SERVICE BULLETIN

Title: 19XL Oil Heater Replacement
Models Affected: 19XL

Number: C9731
Date: 10/27/97
Supersedes: New

To inform of a new oil heater design for 19XL centrifugal chillers.

Figure 1
Oil Heater and Schematic

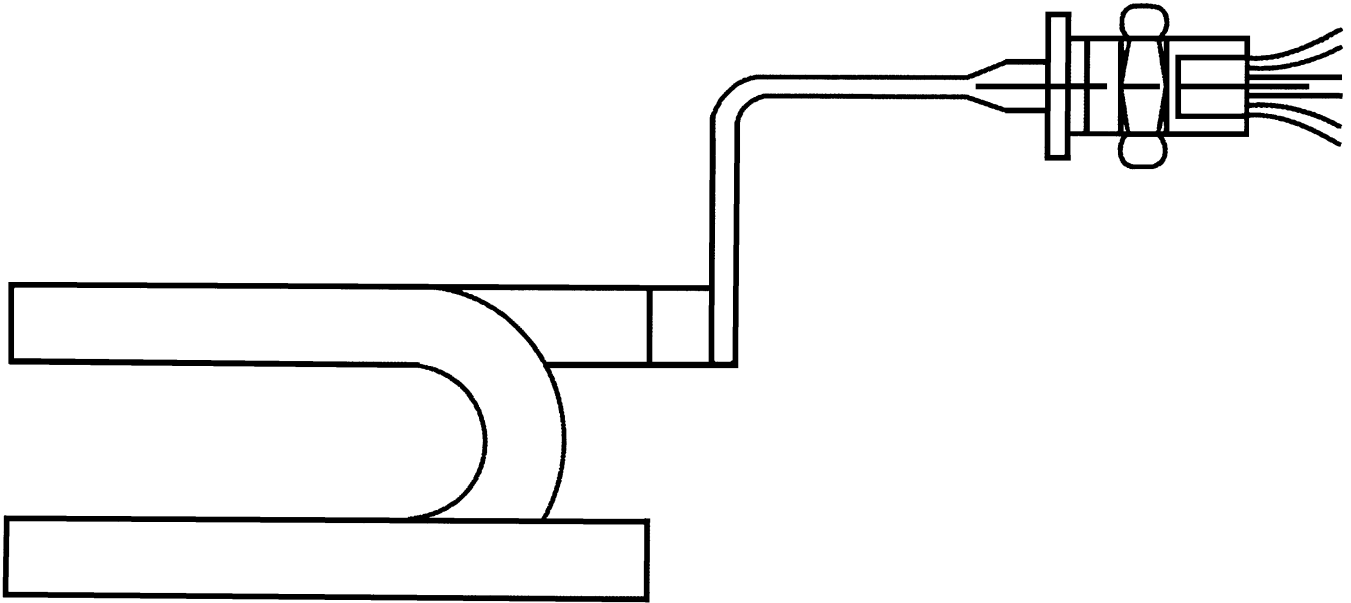
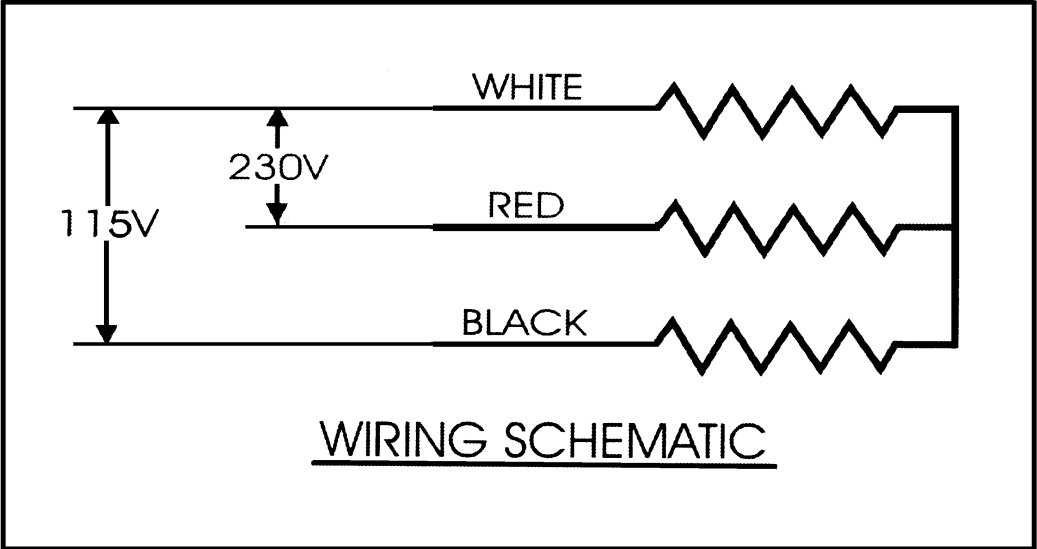
The 19XL oil heater has been redesigned to reduce the temperature stratification during off cycle oil heating. The original oil heater was a 1200 watt heater whose element was configured such that it lie in a plane. The oil heater effectively heated the oil from the bottom plane of the heater to the top of the sump. The oil temperature sensor which controls the heater is located more toward the top of the sump. Because of natural convection of heat and not much conduction occurring the oil that was located below the oil heater was significantly cooler than the oil above it. This leaves the oil located at the bottom of the sump susceptible to being more saturated with refrigerant. This condition could lead to a reduction of lubrication.

The new oil heater is a 1200 watt heater and is configured so that the heater element follows the contour of the sump. This allows part of the heater element to be located in the bottom of the sump (see Figure 1), reducing the temperature stratification of the oil in the sump.

Installation: Installation and wiring of the heater is identical to that of the existing heater (see Figure 1 for schematic). The oil pump must be removed to allow removal and installation of the new heater.

The new oil heater part number 02XB05003201 is available in RCD as a replacement part.
